## CITY OF CARMEL-BY-THE-SEA PLANNING COMMISSION Staff Report

November 10, 2021  
PUBLIC HEARINGS

**SUBJECT:** **DR 21-114 and UP 21-266 (The Conservatory)** Consideration of a Design Review and Use Permit Application for the establishment of a music recording studio and remodel and structural seismic retrofit of an historic 5,857 square-foot structure, including the addition of a 986 square-foot interior balcony, staircase, elevator, a 20 square-foot basement addition, installation of new solar panel array, new skylight and exterior windows to the China Arts Building located at Dolores Street 2 northwest of 7th Avenue in the Central Commercial (CC) Zoning District and Downtown Conservation District (CD) Overlay; APN: 010-147-006-000

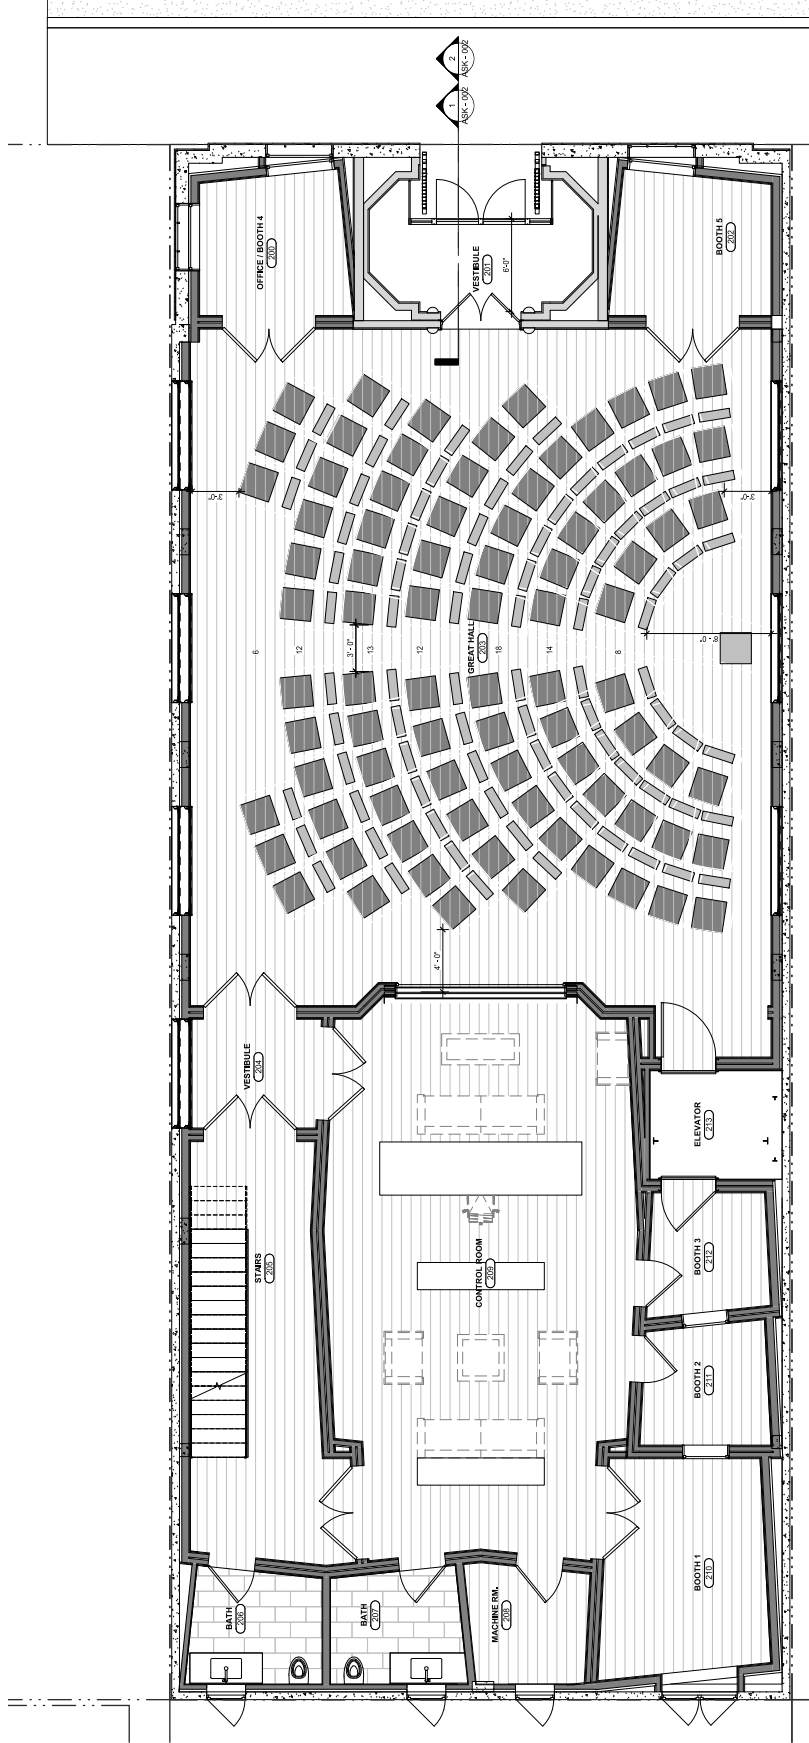
In review of the supplemental information, staff identified that the orchestral seating layout provided (both with and without the sound lock on the interior) would exceed the maximum building occupancy of 49 persons as established in the Building and Fire Codes for a "B" (business) occupancy building. Occupancies of more than 49 persons would change the building to an "A" (assembly) occupancy during those occurrences, however, the building would not be permanently classified as an "A" occupancy.

To accommodate occupancies exceeding 49 persons on a temporary basis (for the purposes of orchestral recording sessions only), planning staff has coordinated with the City's Building Official, and Monterey Fire to draft Special Condition of Approval #24 which states:

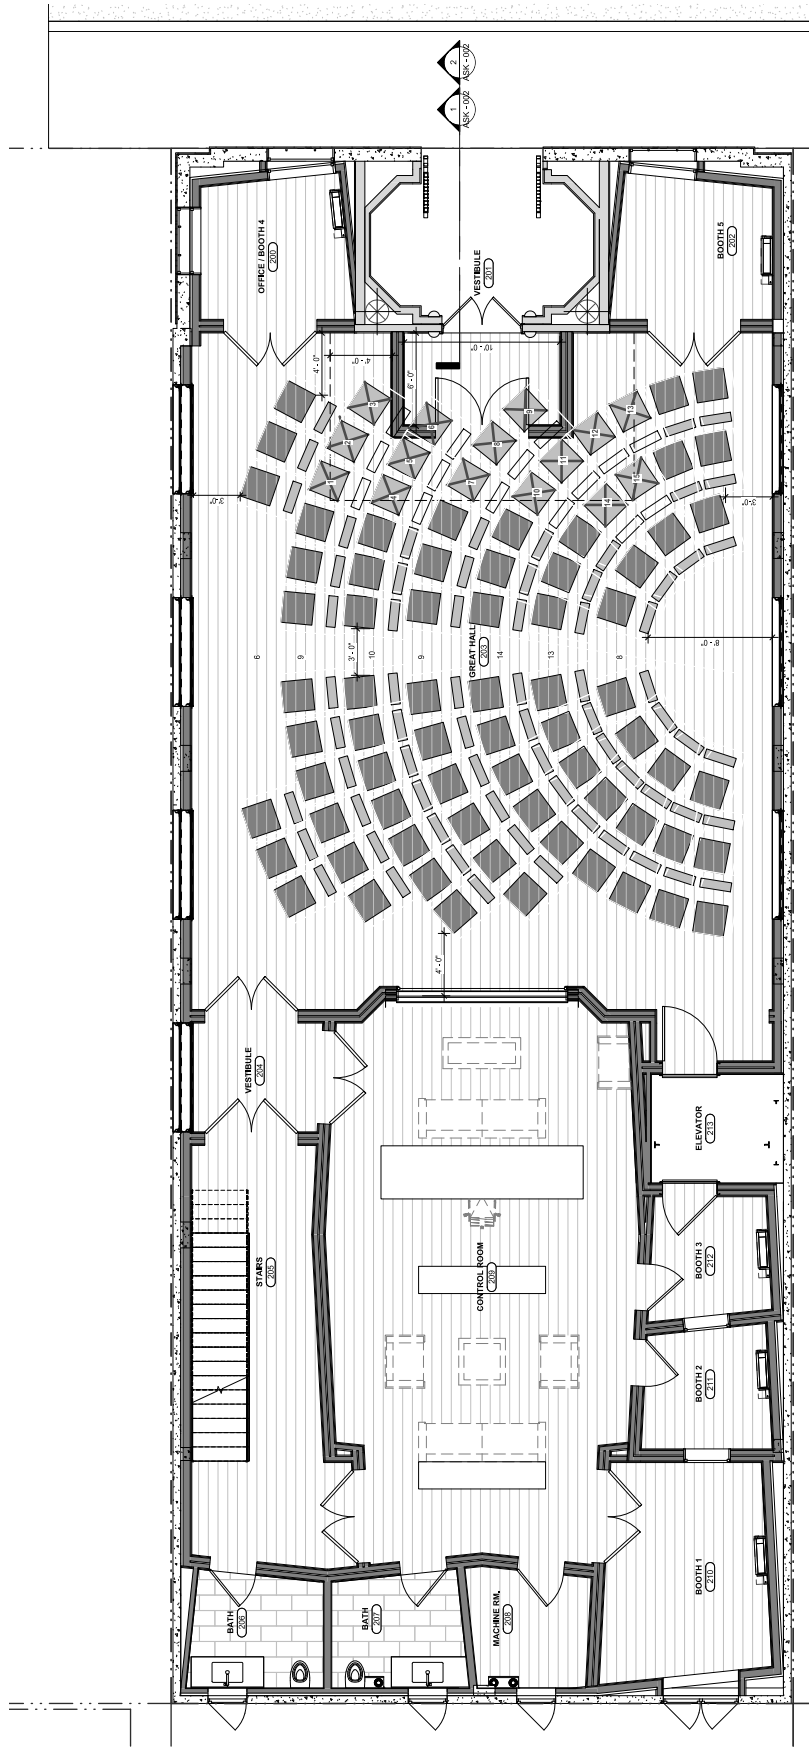
**Response to Direction:** In response to the Planning Commission’s direction to “explore providing a design that will have the sound lock on the interior of the building instead of the exterior of the vestibule,” the applicant has not provided revised drawings, but rather has submitted supplemental information to support their position that the location of the sound lock on the exterior of the building is more efficient for the use and sound attenuation than if located in the interior (Attachment 3).
